Florida Department of Environmental Regulation

Re: Drum Painting Operation (AC 53-187548)
Drum Reconditioning Furnace (AC 53-187549)

The Department has reviewed your applications for permits to construct a drum reconditioning furnace and a painting operation at the Lakeland Drum Service facility in Polk County, Florida. Before we can continue the processing of these applications, the following information needs to be submitted:

Technical Evaluation
and
Preliminary Determination

**Plot Plan Showing Boiler Location
and
Flow Diagram of Boiler Operation**

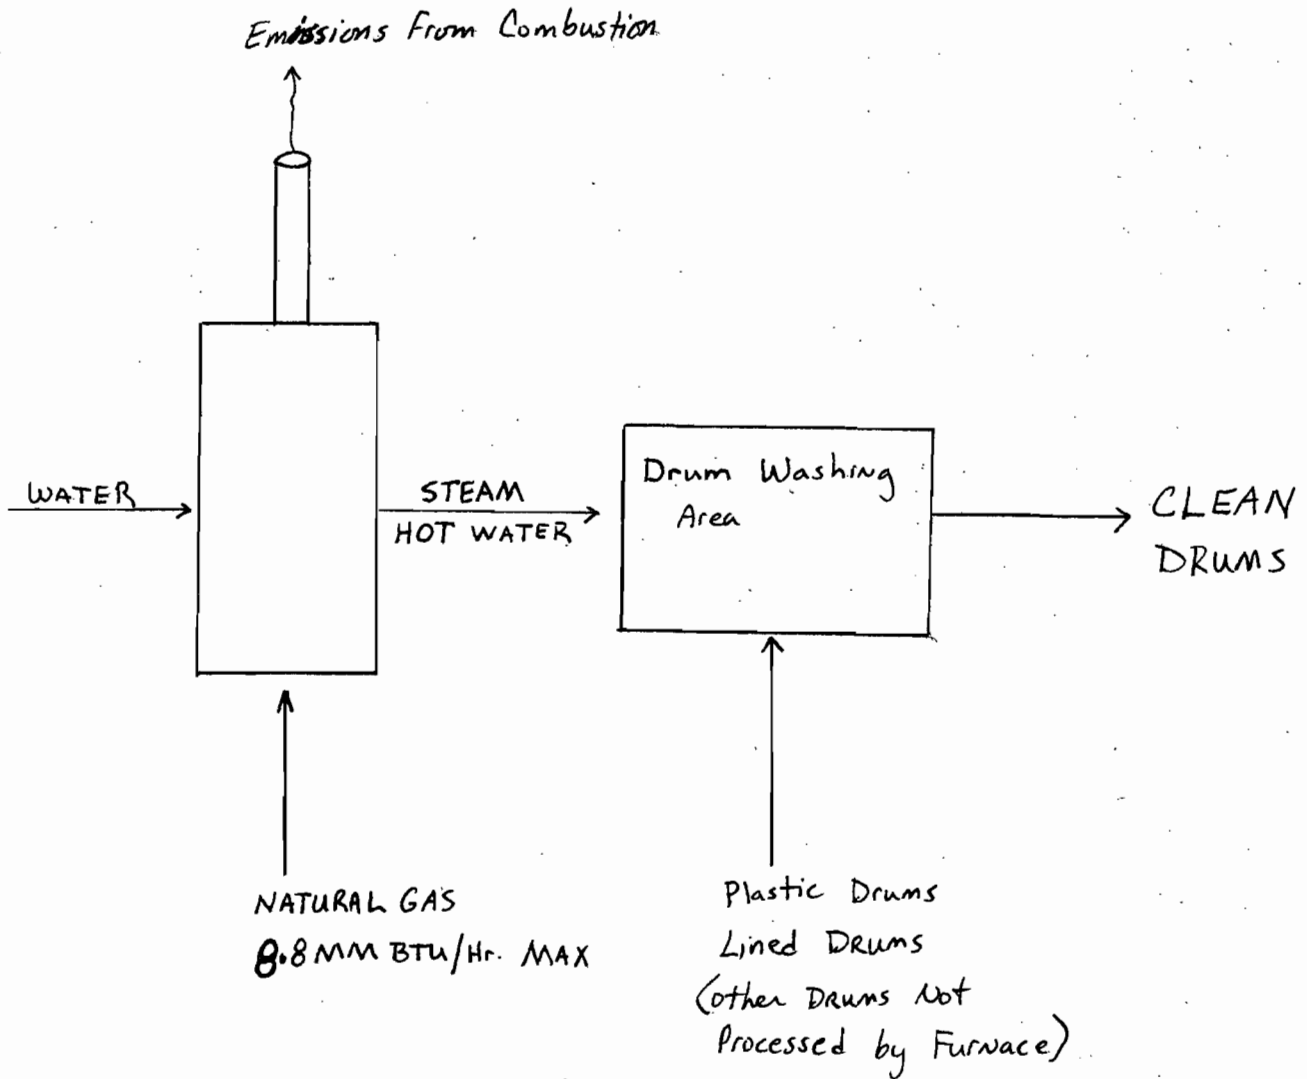
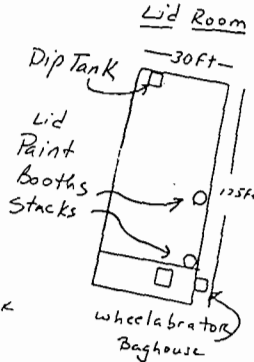
5. What will be the function of the 200 HP boiler (steam generator and/or afterburner)? Explain. Show the boiler's location in a flow diagram.
6. Calculate the acceptable ambient concentrations (AAC) for each of the hazardous ingredients listed in Section II of the material safety data sheets (MSDS) for this operation.
7. Is any baking ovens associated with this operation?

The boiler generates steam and hot water only, is independant of other sources, and has nothing to do with an afterburner. The location of the boiler is identified on the attached plot plan referenced as supplement 8. The hot water is used to clean
